Project	IEEE 802.16 Broadband Wireless Access Working Group < http://ieee802.org/16 >	
Title	Amendments for Coexistence of High Density Fixed Systems (HDFS) Point-to-Multipoint (PMP), Point-to-Point (PTP) and Mesh Systems	
Date Submitted	2001-03-06	
Source(s)	Peter A. Soltesz / Fred Ricci / Brandon Hinton Winstar Communications, Inc. 2545 Horse Pen Road, Herndon, VA	Tel: 703-889-6430 / 703-889-6477 /703-889-6404 E-mail: p.soltesz@ieee.org , fricci@winstar.com , bhinton@winstar.com
Re:	IEEE PAR 802.16.2	
Notice:	This document was approved by the <i>Wireless Communications Association (WCA) Engineering Committee</i> for submission to the IEEE 802.16.2	
Abstract	<p>Whereas there are, and will continue to be, High Density Fixed Service (HDFS) system deployments consisting of a significant mix of Point-to-Multipoint (PMP), Multipoint-to-Multipoint and Point-to-Point systems, a recommended practice for coexistence should be inclusive of these types of deployments. In fact recommendation 6 of the current practice refers to this need.</p> <p>The scope of such a practice should investigate and amend the susceptibility of Point-to-Point (PTP) stations that exist, either co-channel or adjacen

Figure 1

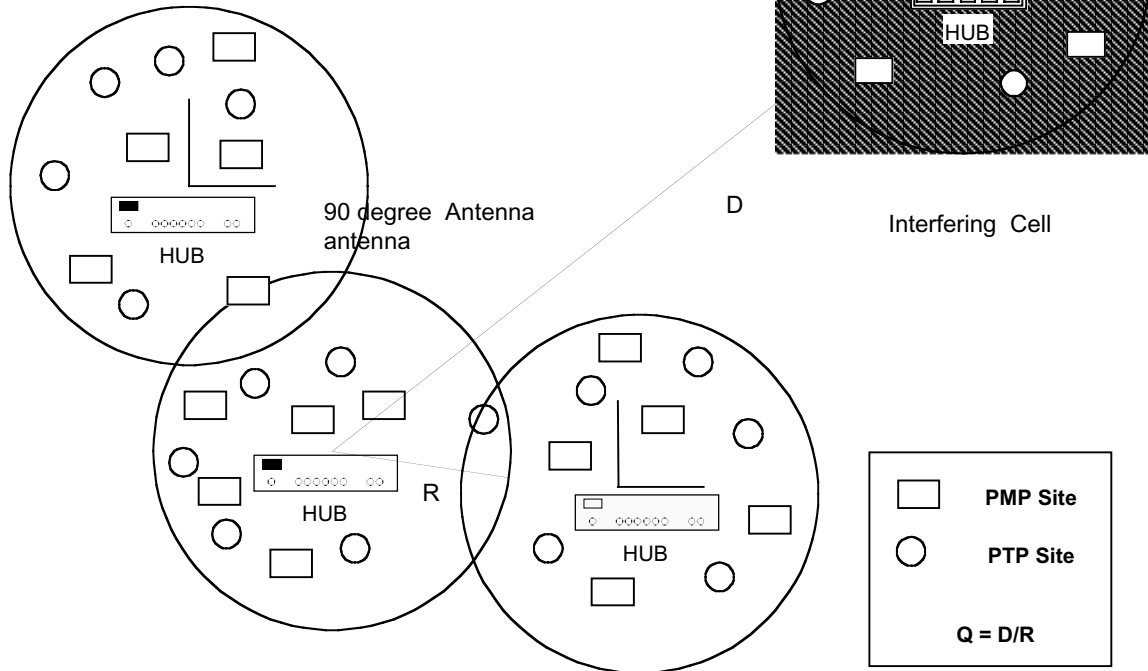
system. The Interfering cell has an impact on the operation of HDFS cells. Thus, the proper coordination procedures must be in place. As can be seen in Figure 1, the Hub, PMP or PTP systems can receive interference from the interfering cell. One critical issue that needs to be addressed is that the interfering cell can cause significantly more interference on the PTP systems than on the PMP systems because of the higher antenna gains of the PTP radios. Included below is a calculation of the interference caused in both the PMP and PTP configurations as considered by the ITU. The fundamental equation for the Power Flux Density (**Pfd**) is:

Figure 1 indicates the co-existence of PTP/PMP and other potentially interfering Networks in a typical HDFS configuration that would exist in Los Angeles, New York City, etc. Interference from the HUB or PTP/PMP radios from a coexisting Network must comply with the **Pfd** s as indicated above. Further interference from GSO/non-GSO Satellites must also be taken into account in considering **Pfd** s for co-existence as specified in ITU documents referred to before. For example, in New York City where the cells are close together (short links), there may be considerable interference from coexisting Networks and GSO/Non-GSOs. Figure 1 should be utilized as a basis for considering the accumulated effects from interferers. Maximum trigger distances can be calculated from this configuration. Various antenna configurations could be utilized to adequately consider the effects of interference, since receive antenna gain and configuration is a factor in determining **Pfd** trigger limits.
